Access Compliance Report Public Rights-of-Way (RR Crossings)

Intersection ID: 51371	Main Street: UNIVERSITY_POINTE_BV	Location: N/A
ADA ID: 45CB03C1CAE3	Overall Compliance: No	Severity Score: 0.0
Codes/Mitigation Info/Possible Solution		Field Measurements/Component Compliance

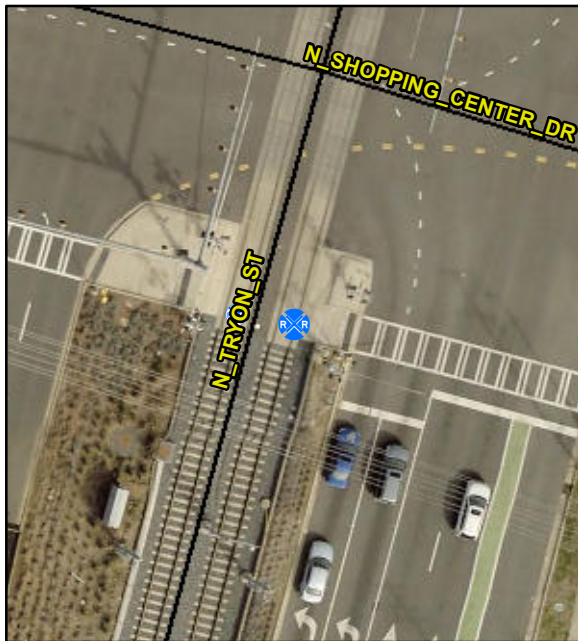
**Install Detectable Warning System.
Remove & Replace Walking Surface
Adjacent to Rail.**

R208.1, R302.7.4

Compliance	Description	Data
No	DWS Provided?	No
N/A	DWS Contrast?	N/A
N/A	DWS Width (in)	N/A
N/A	DWS Length (in)	N/A
N/A	DWS Offset (in)	185.0
Yes	Pedestrian Gate?	Yes
N/A	DWS Outside Gate?	No
N/A	Rail Type?	LightRail
No	Flangeway Gap (in)	2.5
Yes	Sidewalk Width (in)	120.0
